Wisconsin Department of Transportation

Proposal #28: 6934-06-73, WISC 2026235
V Biron, CTH U
Biron Drive South to Huffman Road
CTH U
Wood County

This is Addendum No. 01, which provides for the following:

ADDENDUM NO. 01

Addendum No. 01
ID 6934-06-73
Revised Sheet 80
February 25, 2026

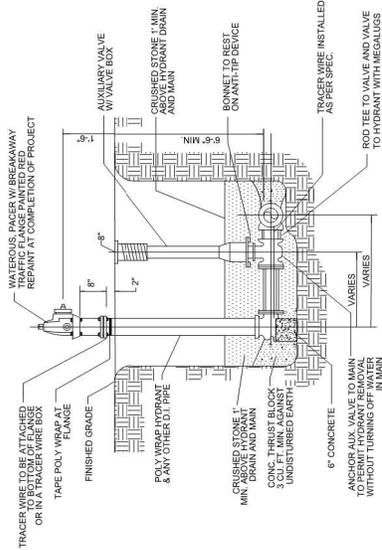
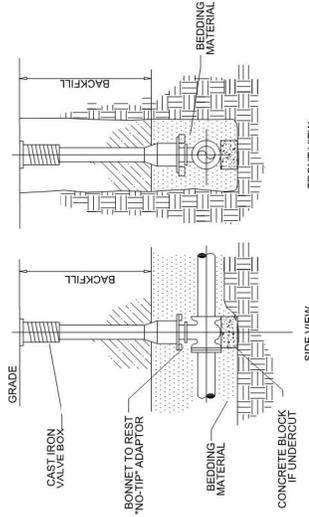
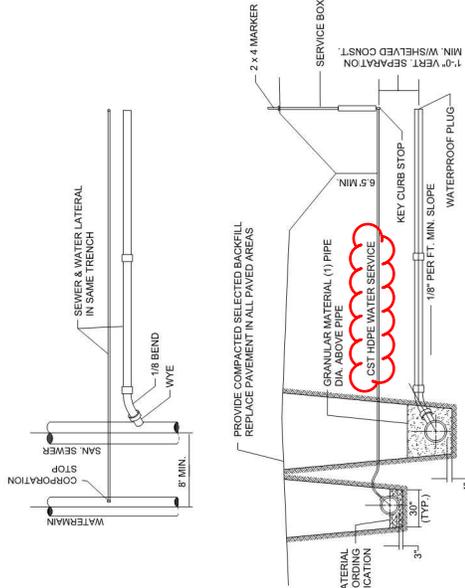
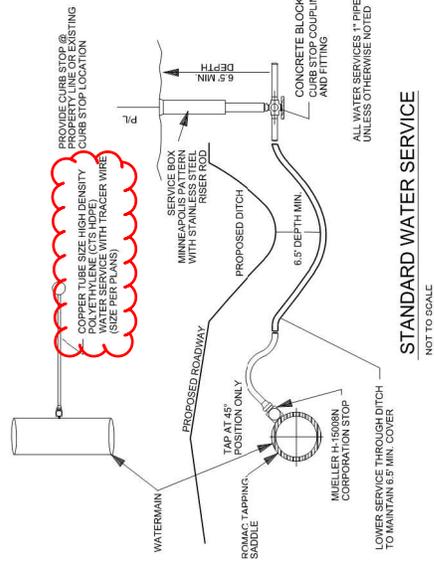
Revised Plan Sheets	
Plan Sheet	Plan Sheet Title (brief description of changes to sheet)
80	Watermain Construction Details (water service material changes)
142	Miscellaneous Quantities (updated items 204.0100 and SPV.0180.01 qty)
172	Miscellaneous Quantities (item SPV.0090.09 name change)
